# Economic and Social Council

#### Working Party on Inland Water Transport

##### Fifty-seventh session

### Report of the Working Party on Inland Water Transport on its fifty-seventh session

**Article 3.01, paragraph 1: The horizontal arc along which the masthead light, the side lights and the stern light are visible.**

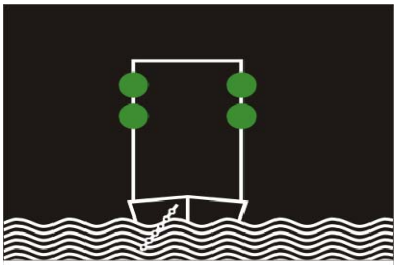
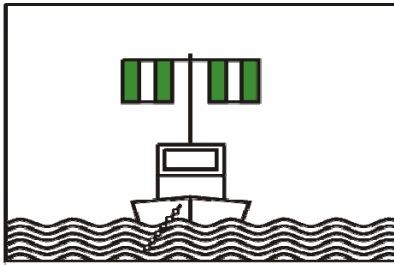
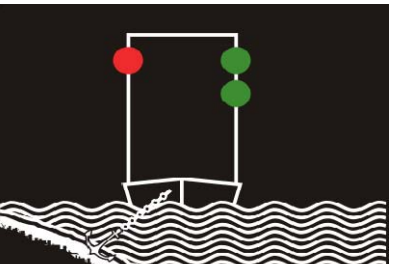
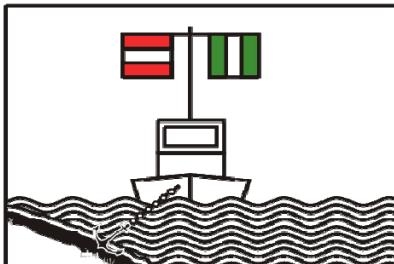
34. *Amend annex 3, paragraph 1.2, as follows*

1.2 The sketches **of this annex** are for guidance only; reference should be made to the text of the regulations which alone is authoritative.

A.1g

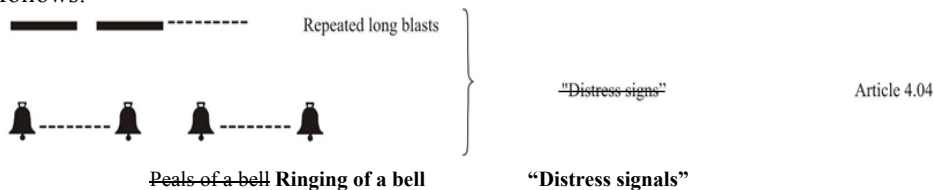
42. *Add a new heading A.1.1 of annex 7*

**A.1.1 Sections closed to use, no entry except for non-motorized small craft (see article 6.22)**
